TECHNICAL BULLETIN

Heating Systems	August 17, 2018	Bulletin Identification No.: MTB-207-10
Release Type: Public

Affected Model(s): Oasis NE-S
Effective Date: August 17, 2017
Effective serial number: NES-XXXX-1055 (including 1026, 1040, 1048)

Description: High Limit Aquastat Change

Figure 1: New High Limit Aquastat (196F)

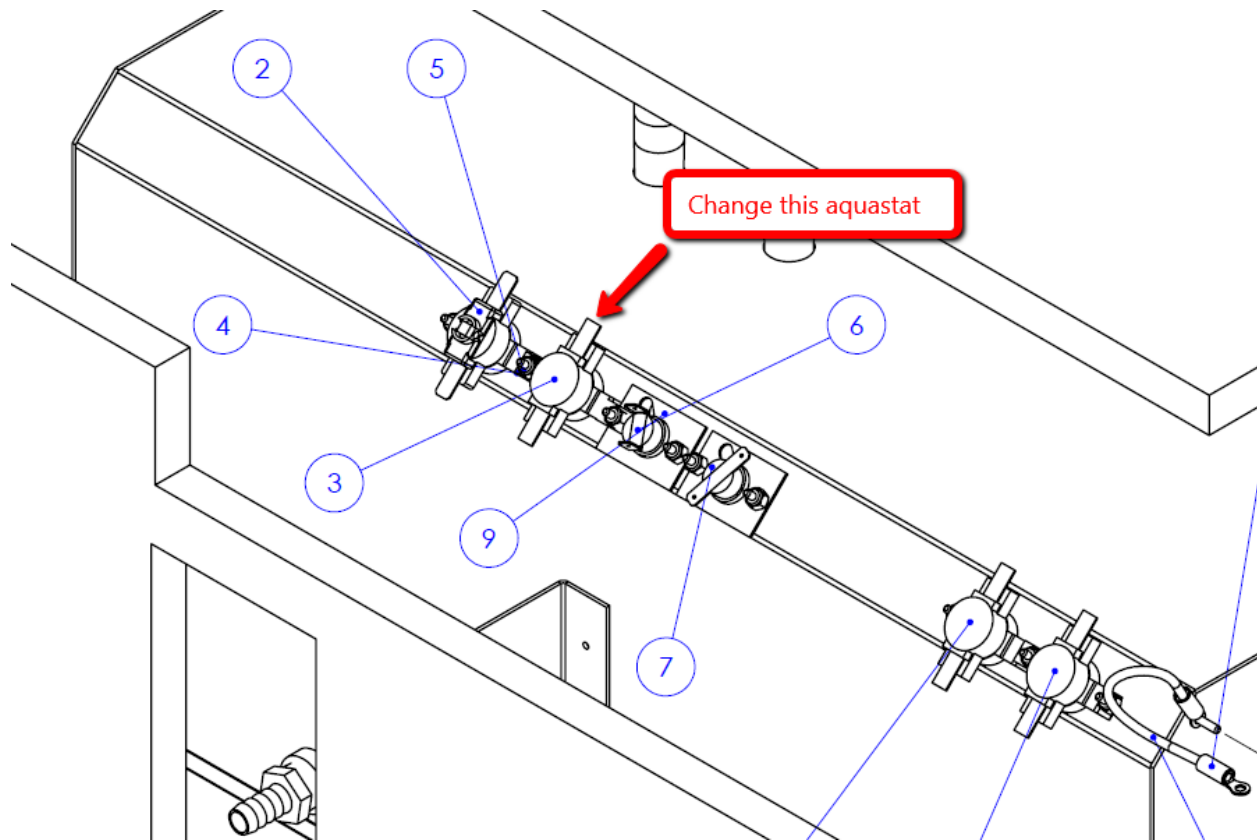
Old Part No. 1128
New Part No. 1138

If the high limit aquastat on the Oasis NE-S trips, the air compressor light will flash. The current aquastat used as the high limit aquastat is too close to the cycling temperature of the heater. This high limit aquastat needs to be replaced with one of a higher value.

When the Aquastat is being replaced, be sure to add thermal compound to the bottom of the new aquastat before securing it in place. Also, when tightening the bolts onto the tank studs, do not over tighten. Using too much force may break the studs from the tank.
